S E R V I C E N O T E

6012B Autoranging DC Power Supply

Serial Numbers: 3104A03481 / 3139A03760

Modification using RTV to prevent W8 Ribbon Cable disconnect.**Duplicate Service Notes:**

Figure 1

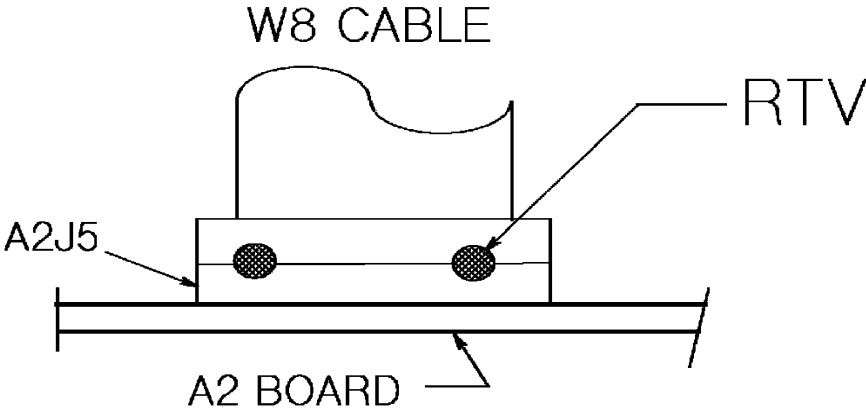
The W8 ribbon cable connecting the A1 main board assembly to the A2 Control board assembly may vibrate loose during transportation. This only involves units with serial numbers inclusive of those listed above.

Reconnect the W8 ribbon cable. Use RTV to secure the W8 connector to the J5 mating connector on the A2 assembly. Put a 8 mm (0.313 in) size spot bridging the W8 / J5 connectors. Bridge the connectors with an RTV spot at each end as shown in figure 1.
